## Design Revisions Document

There were 15 key areas of concern raised by the planning officer:

During the course of the planning application process officer's have raised a number of design related matters for consideration by the applicant. This document was first produced in early August 19 and submitted at a meeting with officers held on Friday 18<sup>th</sup> August 2019. At the meeting these matters were discussed. Since the meeting the applicant has instructed us to respond to some of the points raised with further design amendments. This document now includes the responses to all design matters raised to date and includes illustration of the design revisions that followed the meeting. The key changes in the proposals since 16<sup>th</sup> August are summarised below:-

1. Proposed Building Impact

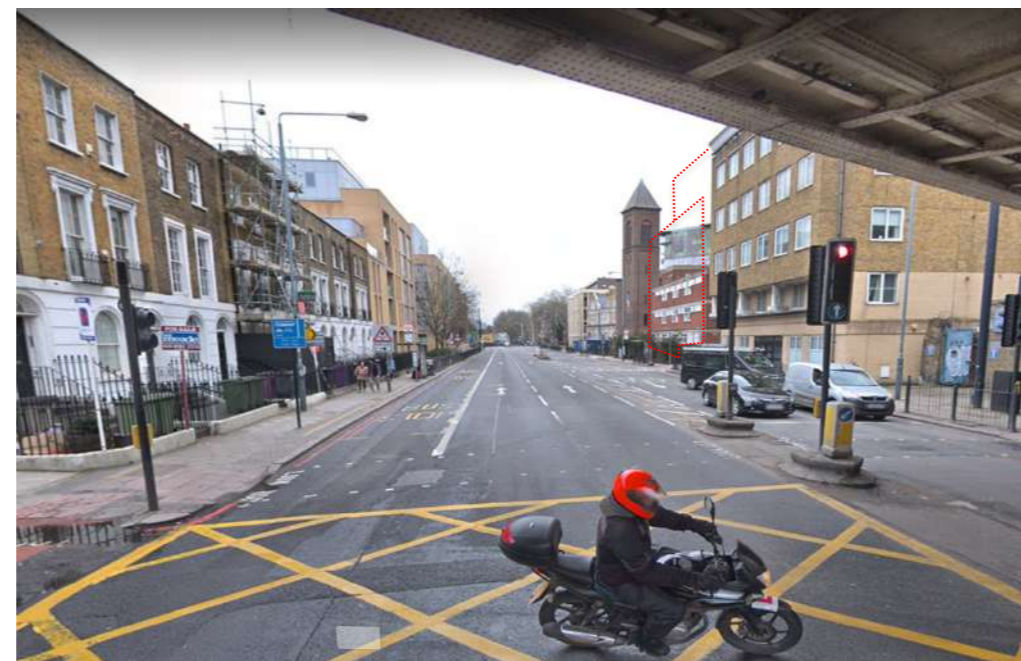
Concern has been expressed over the visual and physical relationship of the proposed building with designated and non-designated heritage assets (including Conservation Area as a whole) and Our Lady Immaculate Church.

The proposal is of similar or less massing compared with the neighbouring buildings, with its setback from Commercial Road and Mill Place curb lines enhancing the breathing space to the adjacent locally listed church.

2. Relationship Existing / Proposed

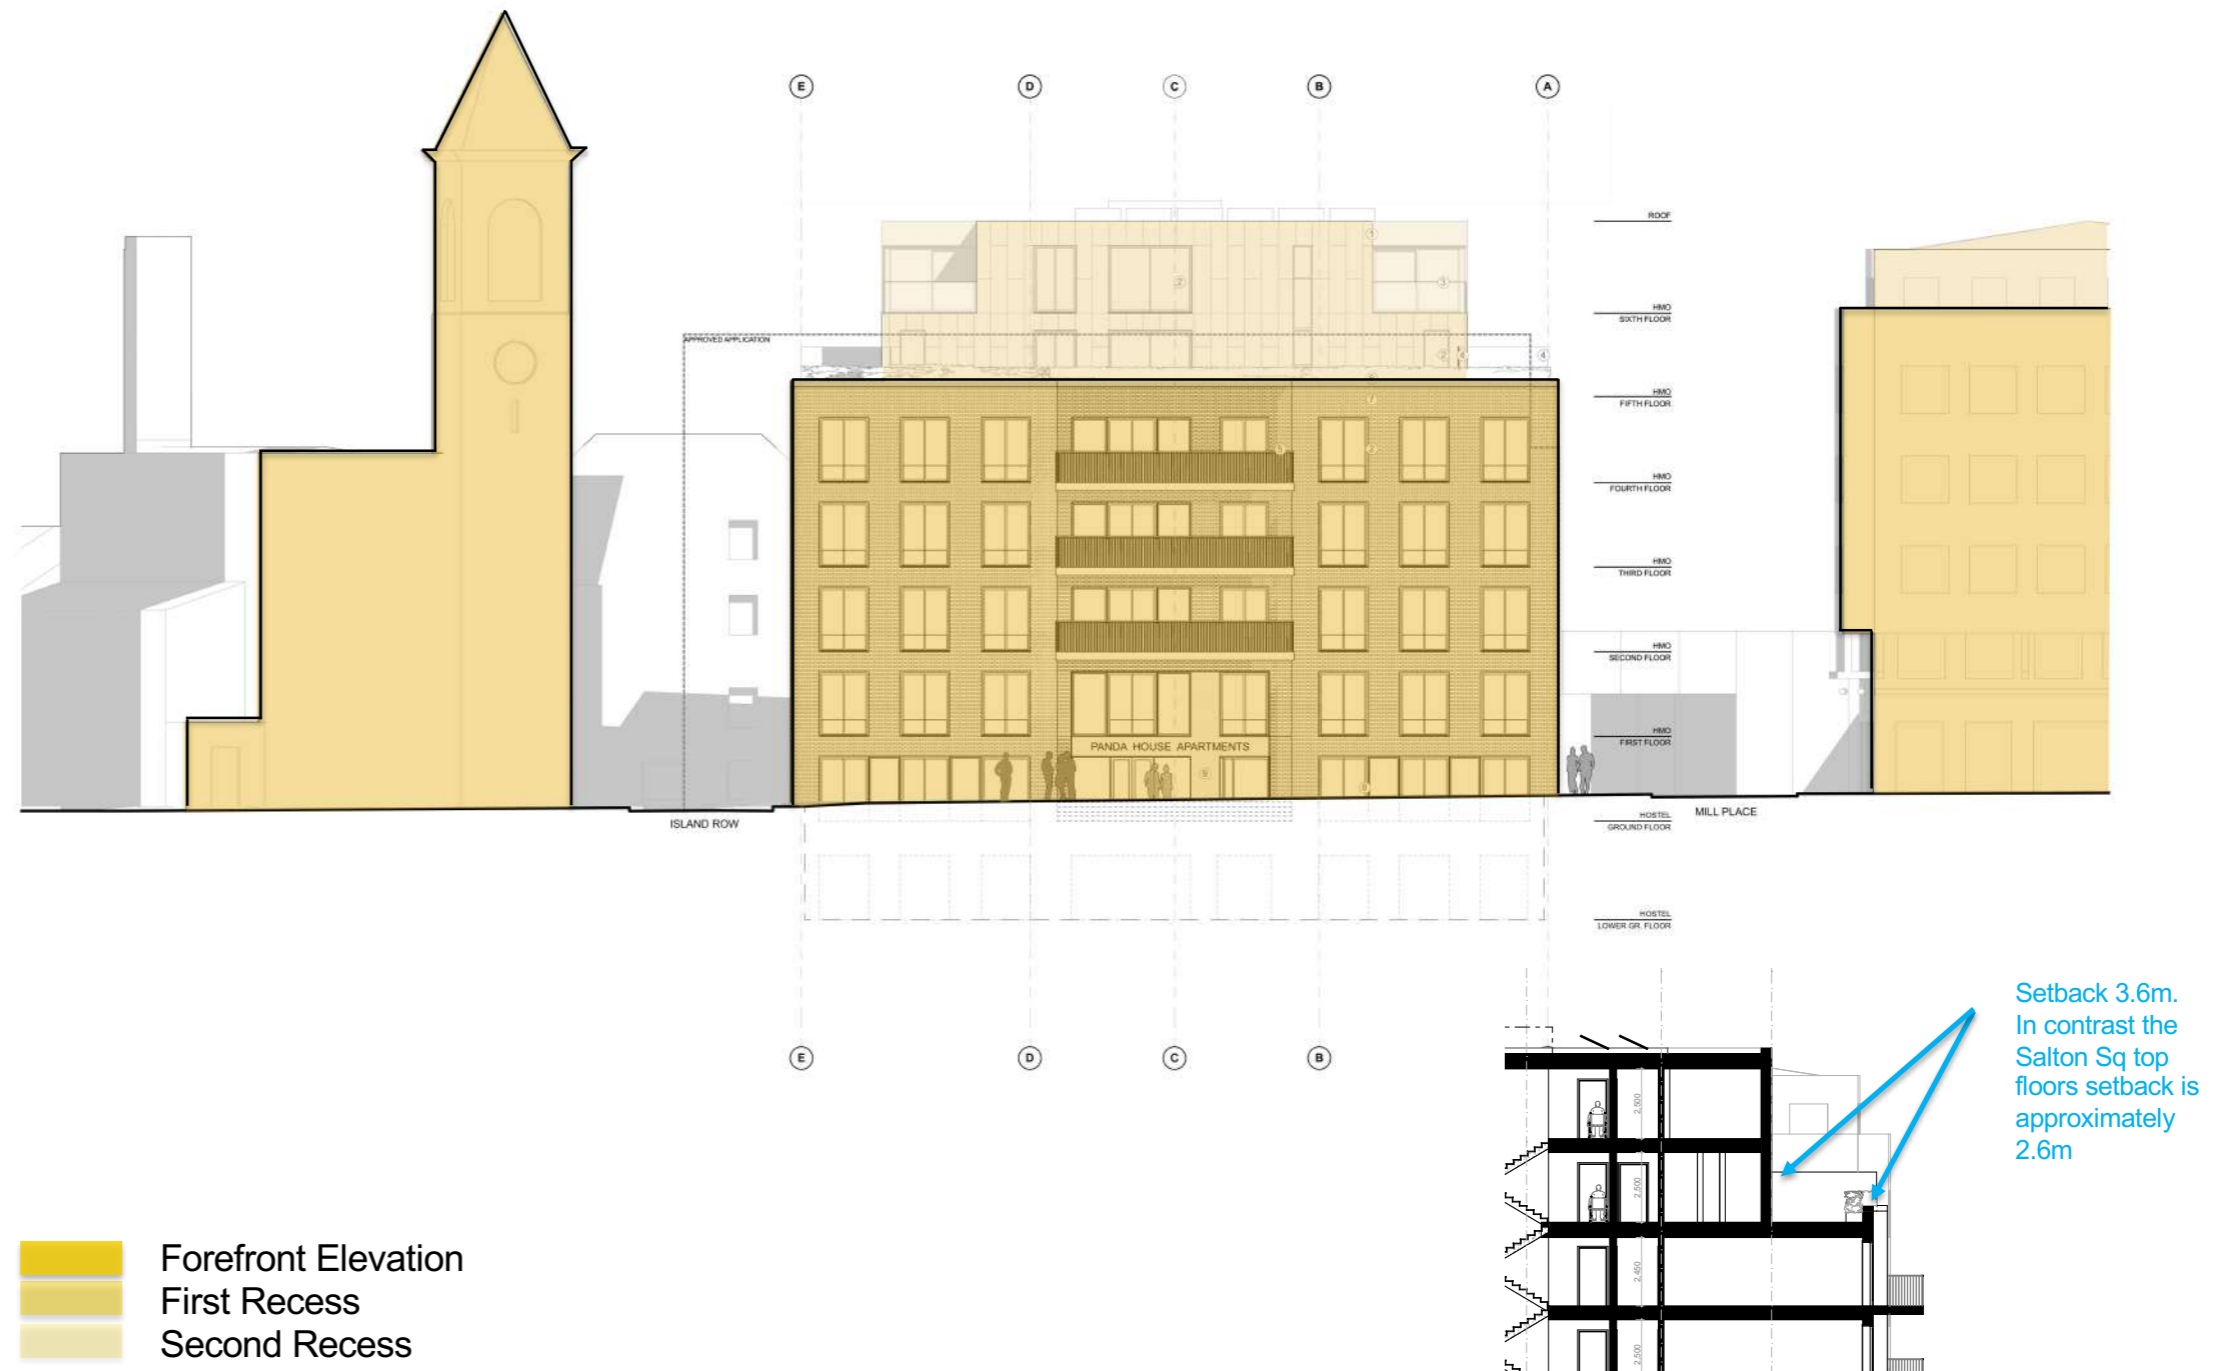
In 2015, a six-storey building was considered excessive and this proposal is for a seven-storey building, which is even taller than the refused scheme.

There are concerns over the overly dominant relationship on the immediate setting of the Church, the Conservation Area and the general townscape character.

The proposed Commercial Road primary façade forms a respectful step between its flanking buildings. Furthermore, the simple and bold tripartite massing of the façade echoes the 'austere exterior' (Pevsner) of the locally listed Our Lady Immaculate church next door. The proposal is lower than the previously consented scheme in terms of the elevation immediately fronting Commercial Road. The upper floors are some 3.6m set back from the street facing elevation and have minimal impact on views of the Church as noted in the earlier pages.

**3. Cohesive Design Scheme**

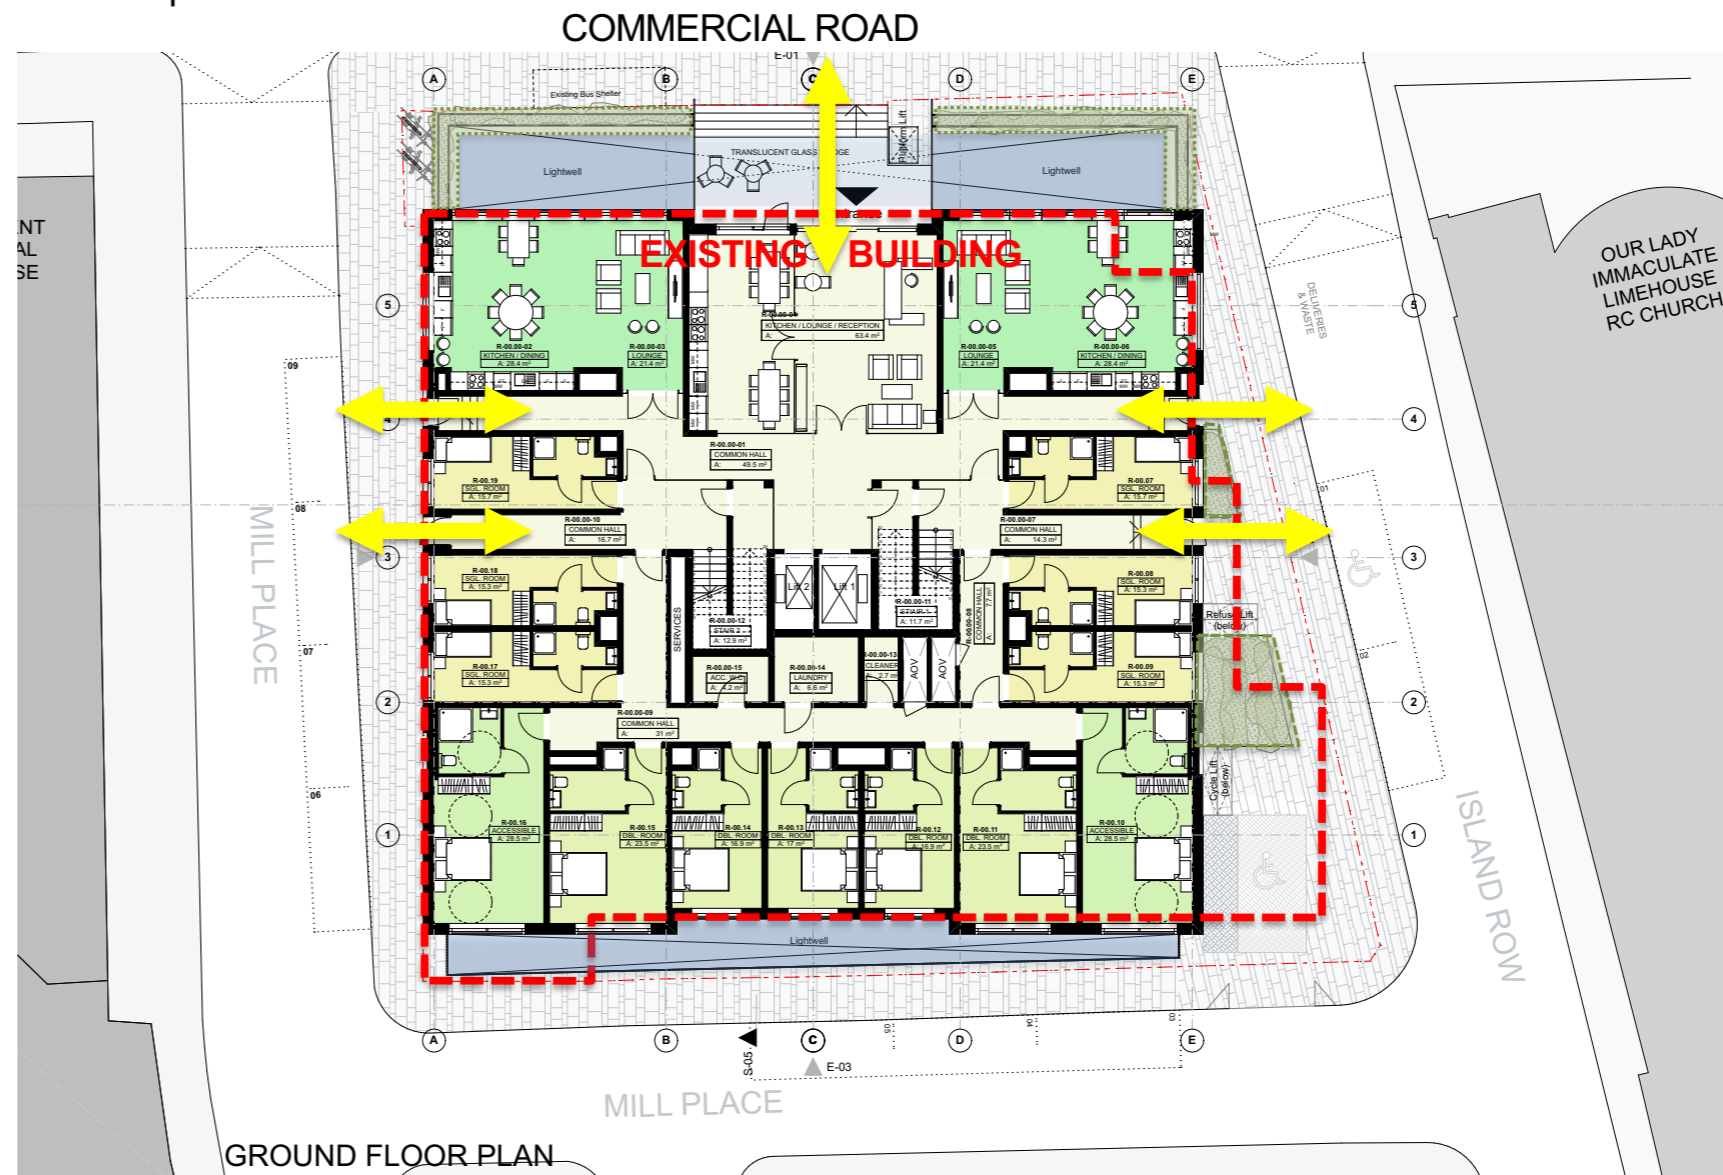
The proposal includes public realm improvements, however, the proposed changes are unconvincing and do not feel as part of a cohesive design scheme.

This is particularly apparent in the location and design of the disabled parking bays and the surrounding footway.

The plot coverage reinforces the poor design of the public realm and draws attention to the potential for vehicular and pedestrian conflict resulting from designing the building and then the space around it.

This approach results in spaces around the building feel like over- incidental and ambiguous spaces that lack clarity of purpose.

The existing building almost completely fills the site and forms a city block. The proposal follows same line along Commercial Road, but with a simpler building form along Island Row. The proposed building sets back along this edge from Island Row, creating some space around the base of the adjacent church. There is mainly hard landscape and some planting to create defensible space against the building edge along with secondary access and egress points. The disabled parking bay is part of a shared pavement surface. The applicant is open to amending this landscape area of the proposal and locating the parking space in the street if this is preferred.
